Our Ref: 2553/BC/KD/160911

**Re: West Wallsend Colliery Continued Operations Project - Proposed Mine Plan Modifications**

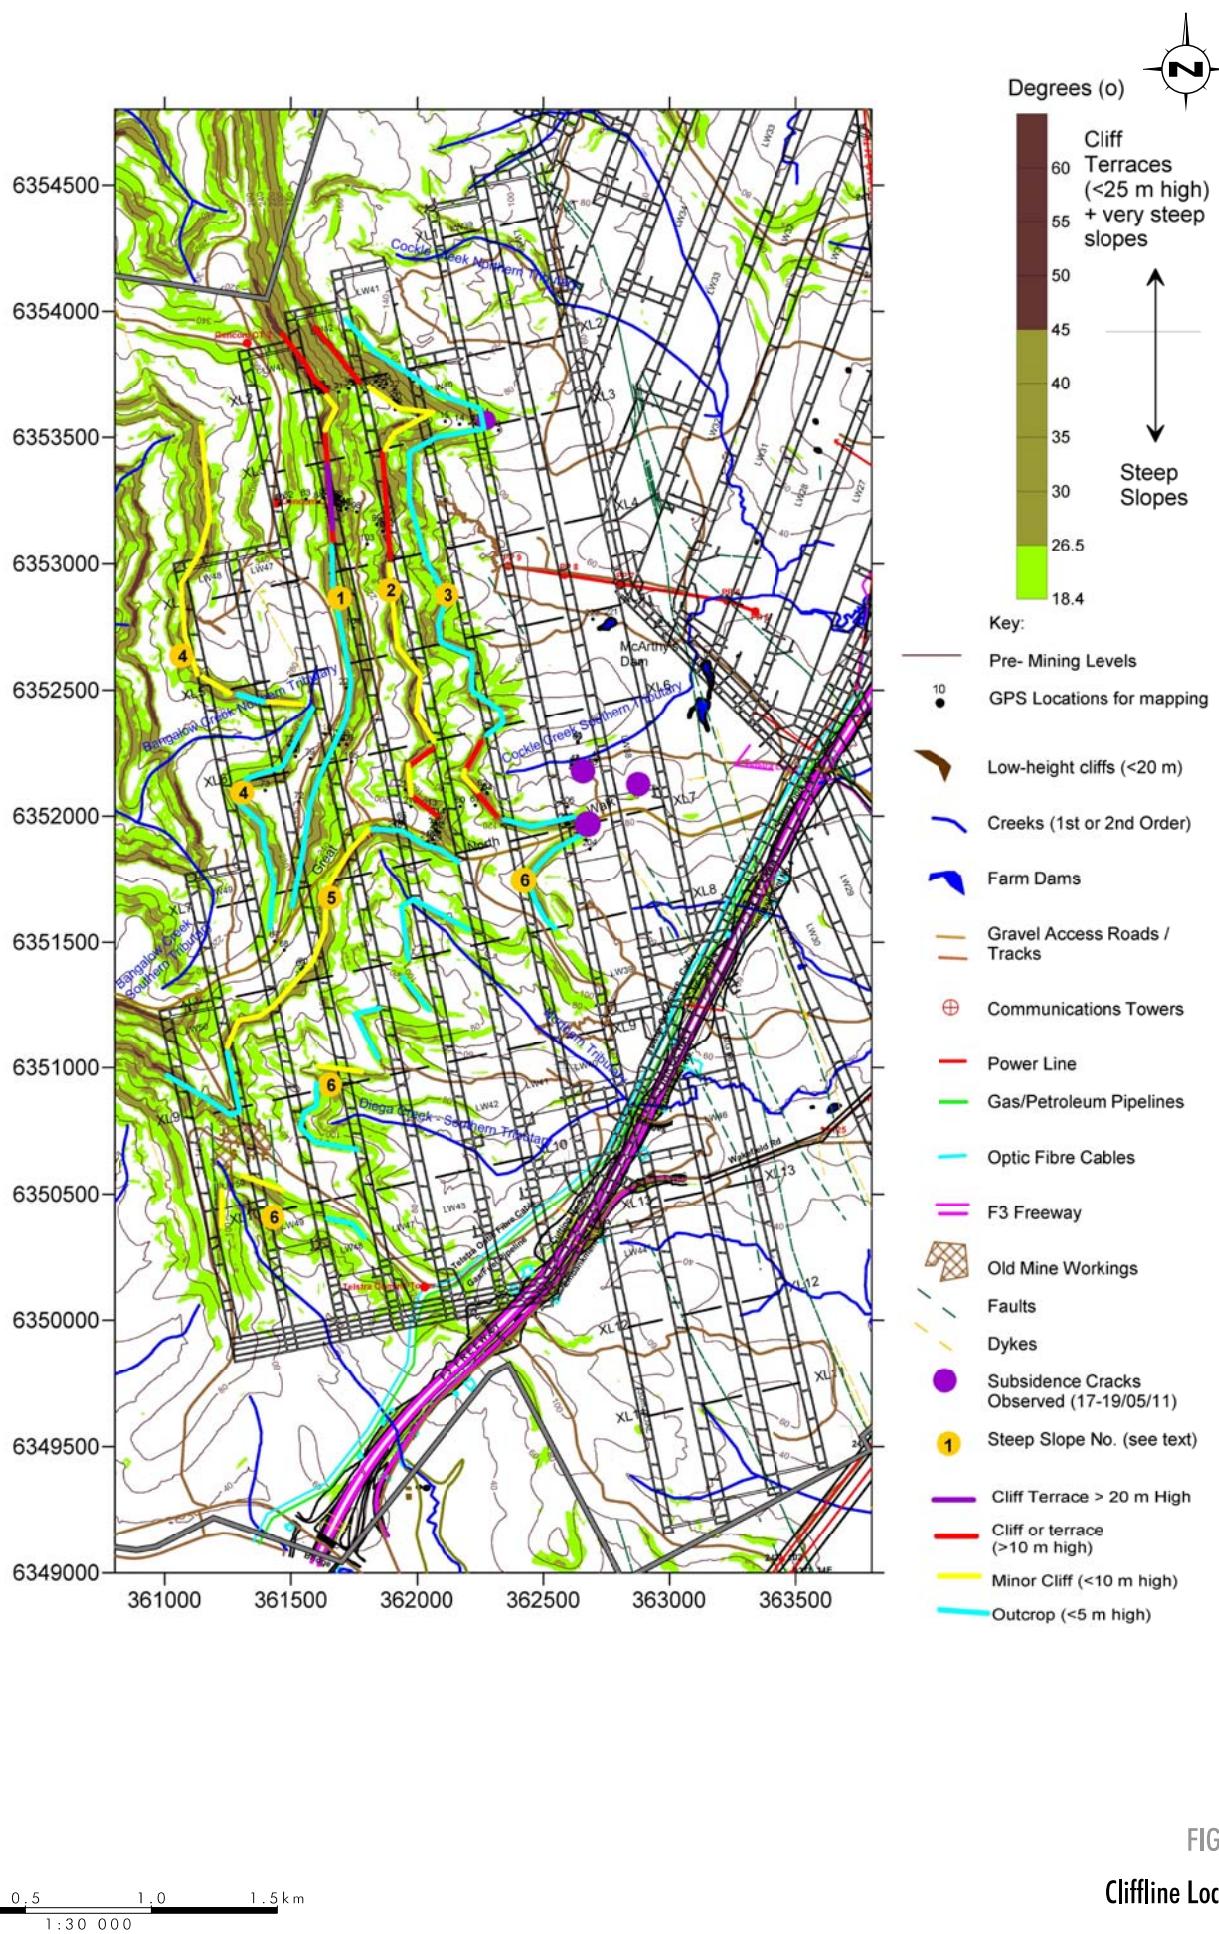
WWC have undertaken extensive further consultation with DTIRIS in regards to their concerns regarding steep slope issues. An additional subsidence assessment has been undertaken to identify the likely and credible worst case impact of the proposed operations on steep slopes and clifflines within the continued underground mining areas (refer to attached *Additional Mine Subsidence Impact Assessment of the Steep Slopes and Cliffs above the Proposed Longwall Panels LW38 to 50 at West Wallsend Colliery*, DgS 2011). One small section of cliffline above 20m in height has been identified and is shown on **Figure1**.

The further assessment identified a number of clifflines and steep slopes greater than 10 m within the continued underground mining area, refer to **Figure 1**. Of these, the only clifflines that may be publically visible are located in the northern extents of Longwalls 42 and 43.

There are additional clifflines greater than 10 metres located in the central portions of Longwalls 41 and 42 (refer to **Figure 1**). The assessment indicates that these clifflines are not publically visible. Additionally, a representative from DTIRIS (Ray Ramage) inspected these clifflines with WWC and confirmed he was comfortable that they are not publically visible. No mine plan modifications are proposed for these clifflines. It is considered the proposed management measures will adequately manage potential subsidence impacts on these clifflines.

**FIGURE 2**

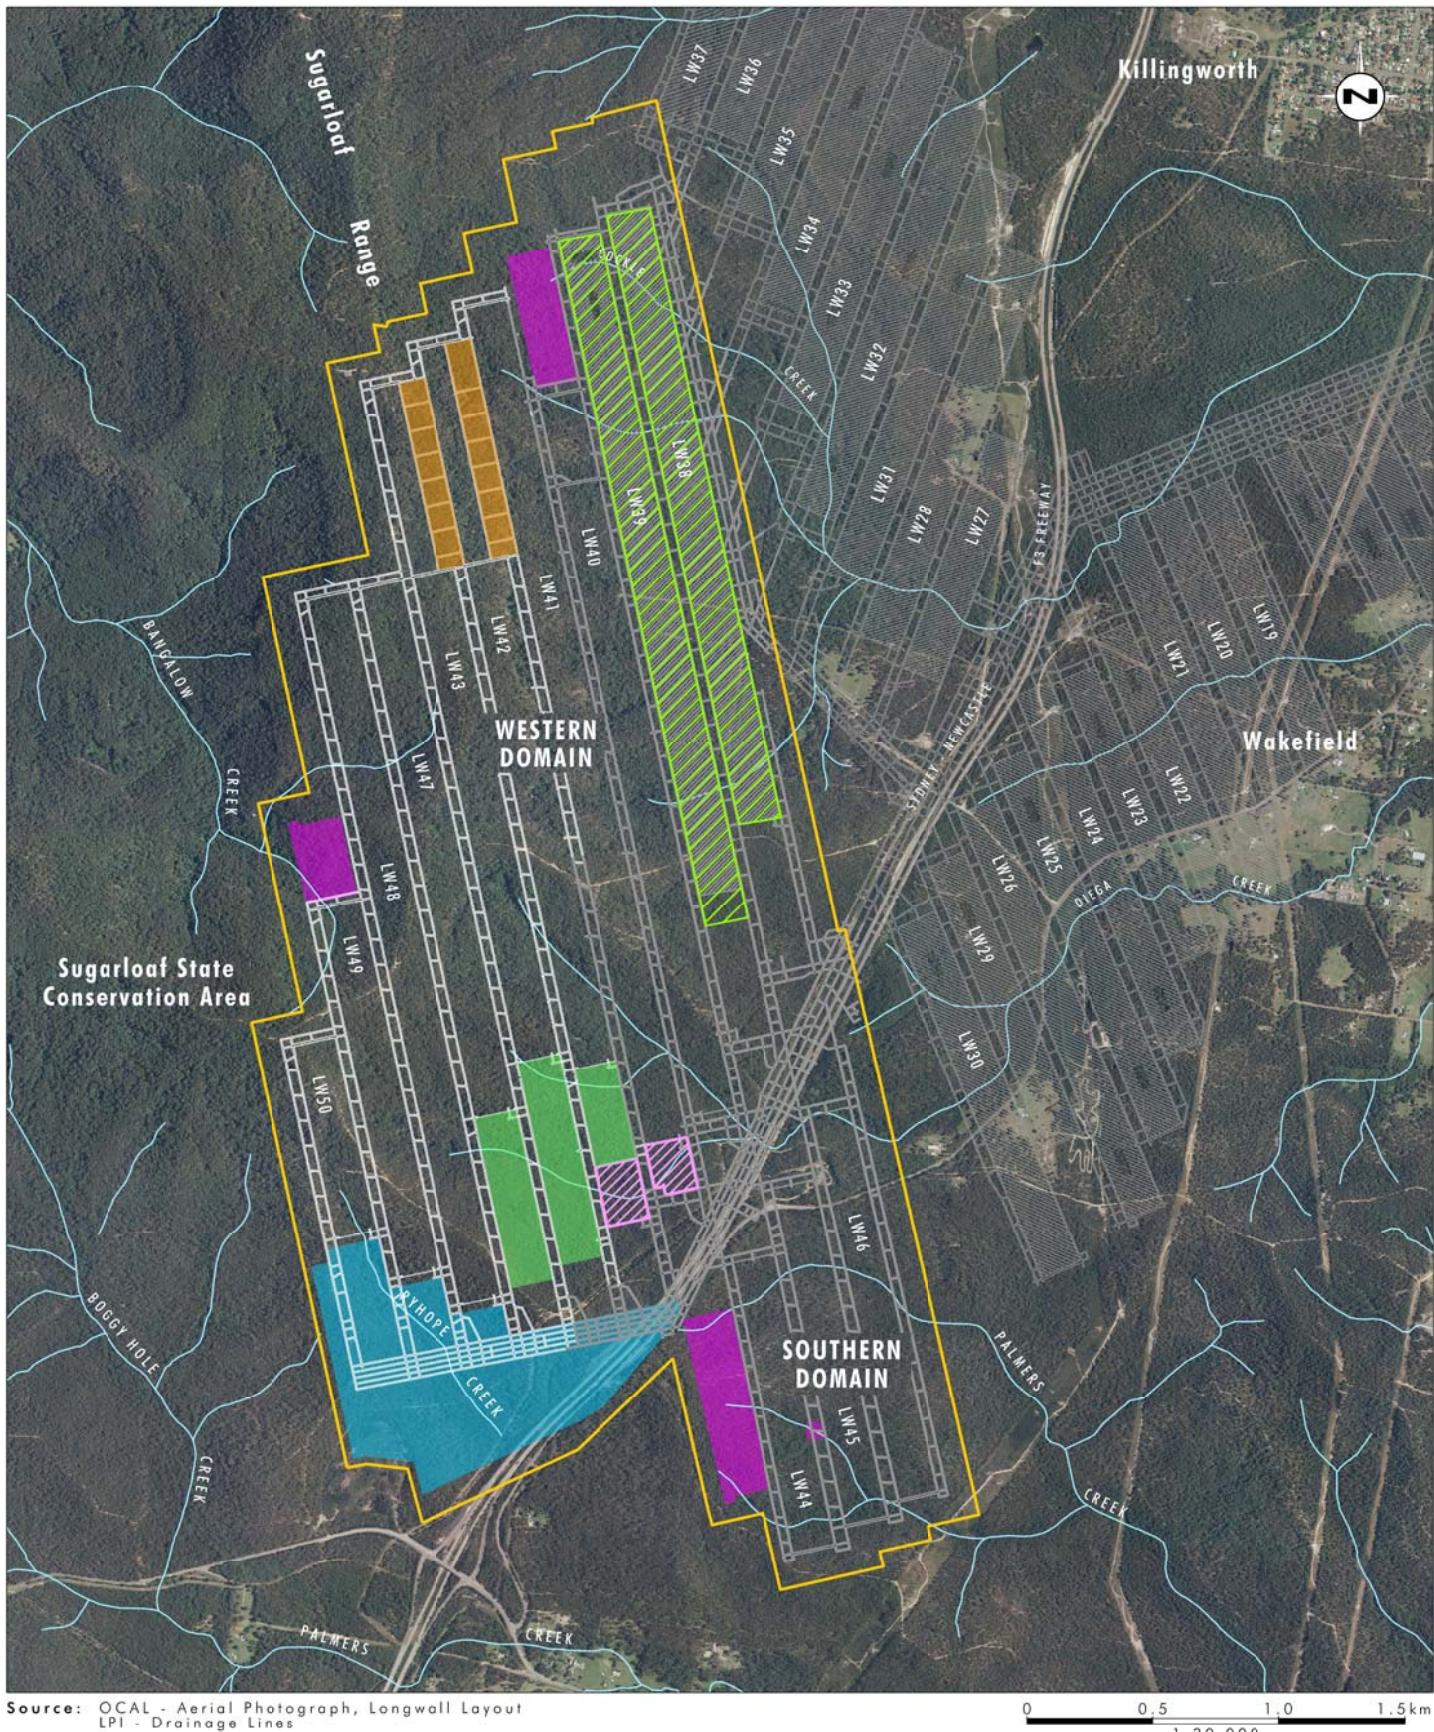
In light of the concerns raised by DTIRIS and the further subsidence assessment, WWC are proposing further modifications to the mine plan. The modification will result in reducing the longwall void width within Longwalls 42 and 43 (refer to **Figure 2**) to 115 metres. The reduced panel width will result in reducing the predicted subsidence impacts to the potentially visible clifflines from 'High' to 'Low'.

Following the proposed mine plan modifications, the cliffs and slopes within the northern extent of Longwalls 42 and 43 are predicted to be subsided by up to 0.2 m. The tilts are estimated to range from 4 to 20 mm/m and the tensile strains likely to be up to 4 mm/m. Surface cracking of 40 mm to 200 mm is now predicted within the upper slopes.

The decision to reduce the panel void widths of Longwalls 42 and 43 from approximately 178 to 115 metres in parts of Longwalls 42 and 43 was based on maximising resource recovery and minimising potential subsidence impacts on the identified clifflines. The proposed modifications will sterilise an additional 0.5Mt of coal resource at WWC. The proposed mine plan modifications will enable appropriate subsidence management plans to be implemented without significant risk to public safety, cliffline aesthetics or damage to existing infrastructure. Ongoing monitoring and review of the effectiveness of the management process will be undertaken as mining progresses.
